[Docket No. CE273; Notice No. 23-07-03-SC]

Special Conditions: Adam Aircraft Industries Model A700; External Fuel Tank Protection During Gear-Up or Emergency Landing

ACTION: Notice of proposed special conditions.

Figure 1 – A700 Side and Front View

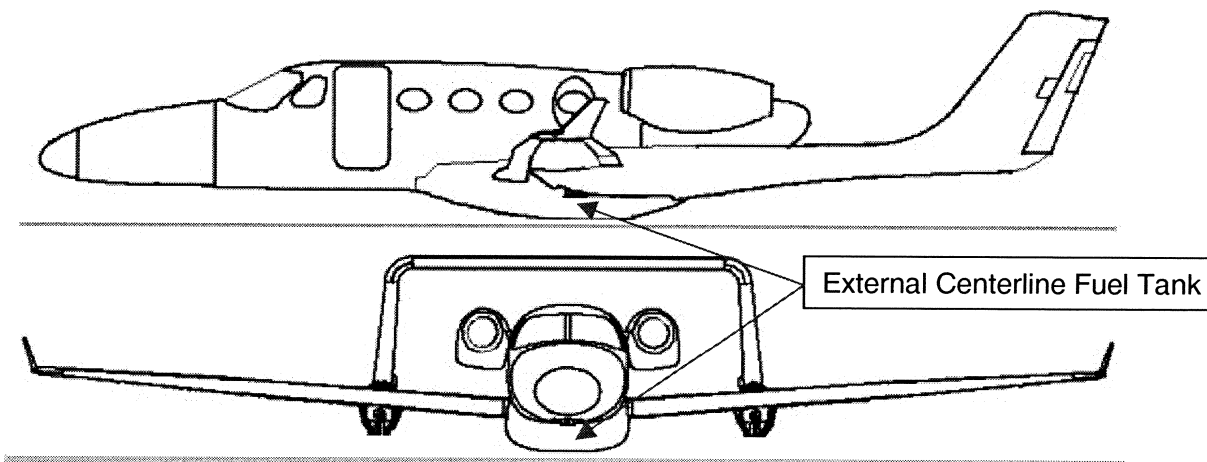
The Adam A700 ECFT is a novel, unusual and a potentially unsafe design feature that may pose a hazard to the occupants during a gear-up or emergency landing due to fuel leakage and subsequent fire. Conventional aircraft construction places the fuel tanks in a protected area within the wings and/or fuselage. Fuel tanks located in these areas are well above the fuselage skin and are inherently protected by the wing and fuselage structure.

The A700 ECFT must meet the inherent qualities associated with the protection of the fuel system as provided by 14 CFR part 23. The FAA requires Adam Aircraft to address the following areas with their ECFT design:

1. *Load Path:* Conventional design approaches establish independent load paths from the keel/skid plate to the airframe major structure where the fuel tanks are isolated from reacting the gear-up or emergency landing loads. The A700 ECFT design must react to the

gear-up or emergency landing loads in a similar manner.

2. *Fuel Management:* Conventional design approaches use fuel tanks located outside of the wings, or wing centerbox, as auxiliary fuel tanks, and not primary fuel tanks. The fuel in the auxiliary fuel tanks is depleted before the primary fuel tanks, thus the auxiliary tanks are usually empty upon landing. In a similar manner, the A700 ECFT must be an auxiliary fuel tank, and not primary fuel tank. The A700 must deplete the fuel in the ECFT before depleting the fuel in the primary fuel tanks.

3. *Location/Geometry:* A700 must preclude the scenario where the fuel tank is the first point of contact with the ground in a gear-up or emergency landing.

4. SC 23.XXX: Fuel tanks within and below the fuselage contour must be installed in accordance with the requirements prescribed in Sec. 23.967. External fuel tank system(s) located beneath the fuselage must have the following design mitigations:

1. The external fuel tank system(s) must be in a protected position so that exposure of the tank to scraping action, or impact, with the ground is unlikely during a gear-up landing of the most critical landing gear or landing gears, when landing on a paved runway.

2. The external fuel tank system(s) must be protected by dedicated protective structure, and the protective structure load paths must be independent of the fuel system during a gear-up landing of the most critical landing gear or landing gears, when landing on a paved runway.

3. The hazard to the external fuel tank system(s) that results from impact by landing gear tire fragments or other likely debris must be minimized.

4. The fuel management of the external fuel tank system(s) must be such that fuel in the external fuel tank system(s) is to be emptied prior to fuel in the main tanks.
